Change No. 13

We have completed our review of the Virginia Electric and Power Company report entitled "Effects of Piping System Breaks Outside Containment - FSAR Appendix D" and as revised in your letters of July 16, July 27, and August 23, 1973. During our review we had the benefit of meetings with your staff at our offices and at the Surry Power Station where we also observed the layout of the major high energy lines. As a result of our review, we have determined that it is appropriate to add an augmented inservice inspection program for high energy lines outside of containment to the Technical Specifications of Facility Operating Licenses Nos. DPR-32 and DPR-37, as discussed below.

4.15 AUGMENTED INSERVICE INSPECTION PROGRAM FOR HIGH ENERGY LINES
OUTSIDE OF CONTAINMENT

MAIN STEAM AND FEEDWATER
 LINES - UNIT 2
 SURRY POWER STATION
 UNITS 1 AND 2

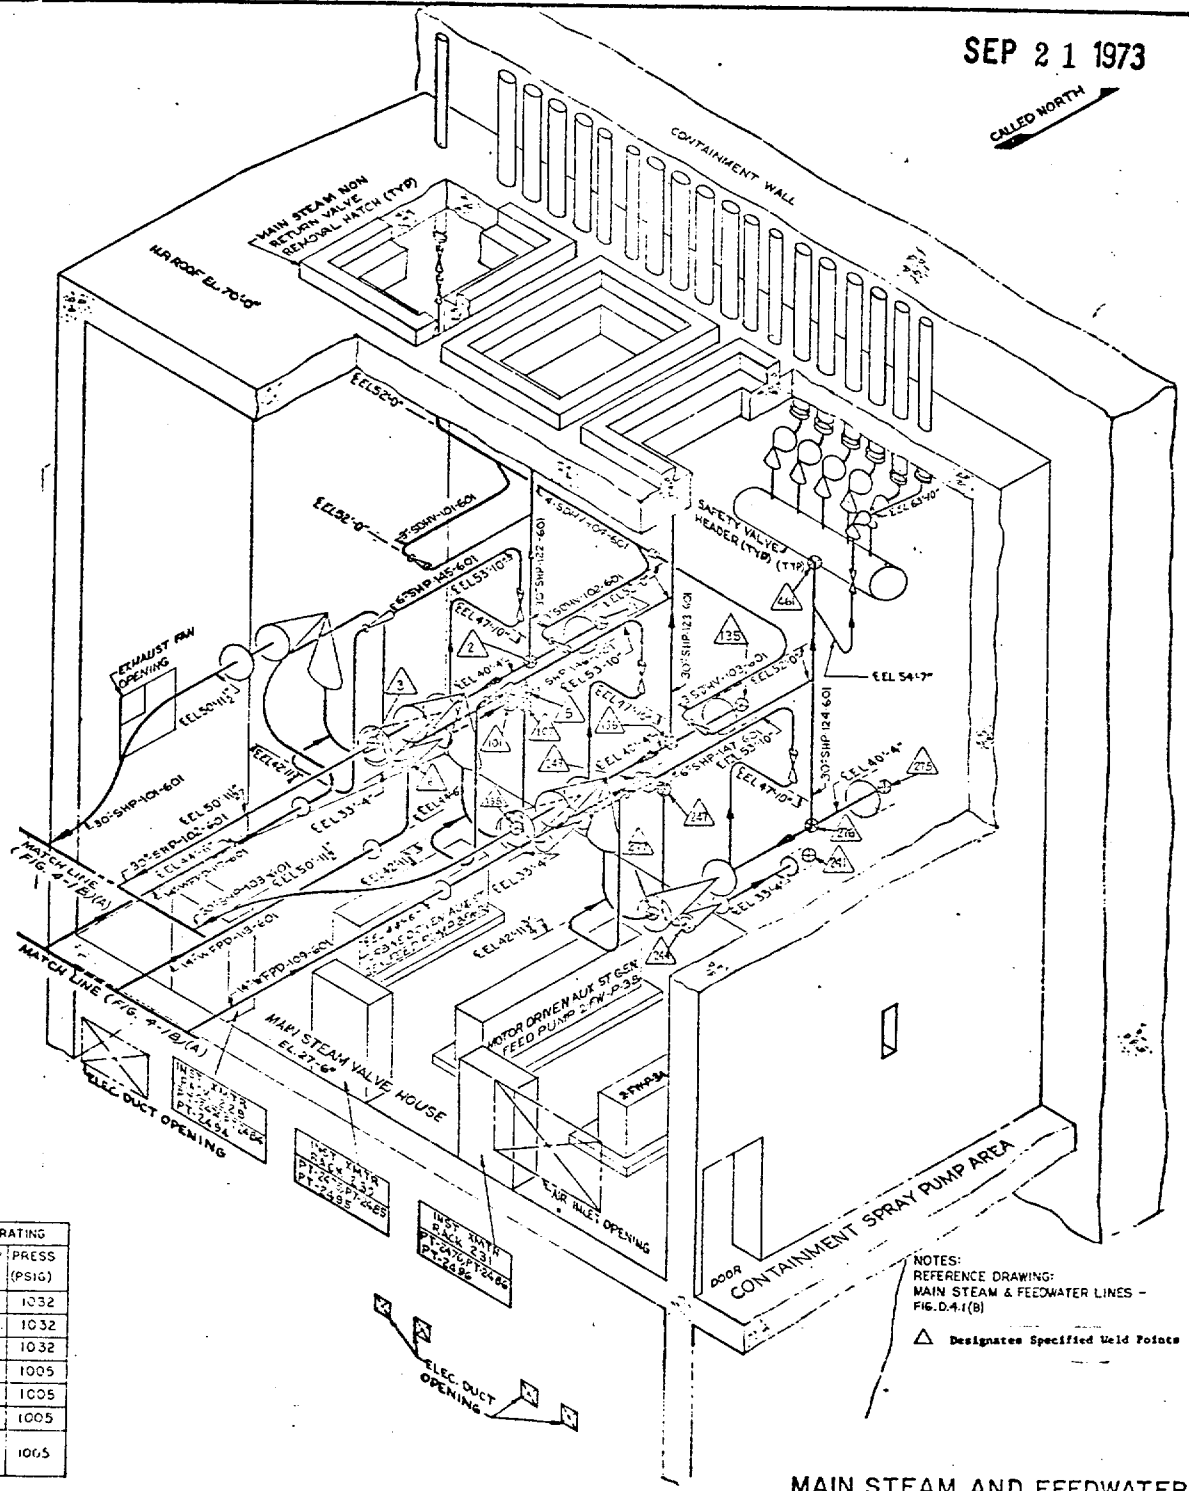
- A. For the 20 welds identified in TS Figure 4.15:
 - 1. At the first refueling outage period a volumetric examination shall be performed with 100 percent inspection of welds in accordance with the requirement of ASME Section XI Code, 'Inservice Inspection of Nuclear Power Plant Components, to

- B. For all welds other than those identified in TS Figure 4.15:
1. Welds in the main steam lines including the safety valve headers and in the feedwater lines in the main steam valve house shall be examined in accordance with the requirements of subsection ISC 100 through 600 of the 1972 Winter Addenda of the ASME Section XI Code.

2. The inservice inspection at each weld shall be performed in accordance with the requirements of ASME Section XI Code, Inservice Inspection of Nuclear Power Plant Components, with the following schedule: (The inspection intervals identified below sequentially follow the baseline examination of TS 4.15.A.1 above):

3. Examinations that reveal unacceptable structural defects in a weld during an inspection under TS 4.15.A.2 shall be extended to require an additional inspection of another 1/3 of the welds. If further unacceptable defects are detected in the second sampling, the remainder of the welds shall be inspected.

4. In the event repairs of any welds are required following any examination during successive inspection intervals, the inspection schedule for the repaired welds will revert back to the first 10 year inspection program.
